March 20, 2020

Southern Nuclear Operating Company
Vogtle Electric Generating Plant Units 3 and 4
Revised Request for License Amendment:
Reconciliation of Environmental Conditions Inputs to Civil Structural Design Licensing
Basis (LAR-19-019R1)

- Enclosures
- 1) Vogtle Electric Generating Plant (VEGP) Units 3 and 4 – Request for License Amendment Regarding Reconciliation of Environmental Conditions Inputs to Civil Structural Design Licensing Basis (LAR-19-019R1)
 - 2) Vogtle Electric Generating Plant (VEGP) Units 3 and 4 – Proposed Changes to Licensing Basis Documents (LAR-19-019R1)

Image 1: Area Excluded from UFSAR Table 3.8.5-3 as Highlighted in Yellow

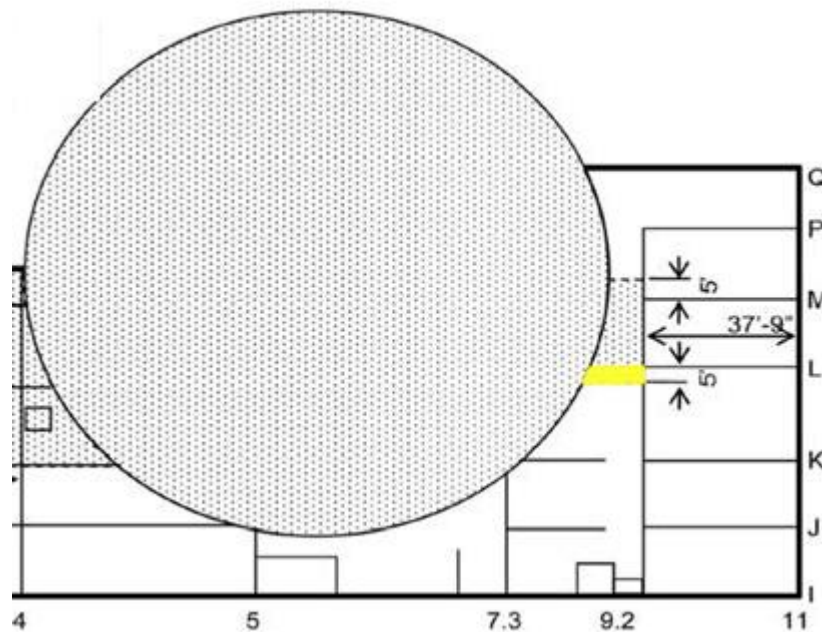
Furthermore, the demands in current UFSAR Table 3.8.5-3 do not include a small portion of basemat (between column line L to 5' east of column line L and shield building to column line 9.2) as shown in UFSAR Figure 3.8.5-3 Sheet 6 and as illustrated in the Image 1 below. However, the table does not identify this exception. Therefore, it is proposed to clarify this information through a note in the table. The proposed markup of UFSAR Table 3.8.5-3 is consistent with the scope of the current UFSAR Table 3.8.5-3, which does not include the small region of basemat.

The addition of the new Note 6 is to clarify that the demands in current UFSAR Table 3.8.5-3 does not include a small portion of basemat (between column line L to 5' east of column line L and shield building to column line 9.2) as shown on UFSAR Figure 3.8.5-3 Sheet 6. This change does impact the intent of the table and does not impact the design of the basemat.

6. The 5'-0" portion of the Basemat between column line L to 5' east of column line and shield building to column line 9.2, as shown in Figure 3.8.5-3, Sheet 6, are not included in this area.
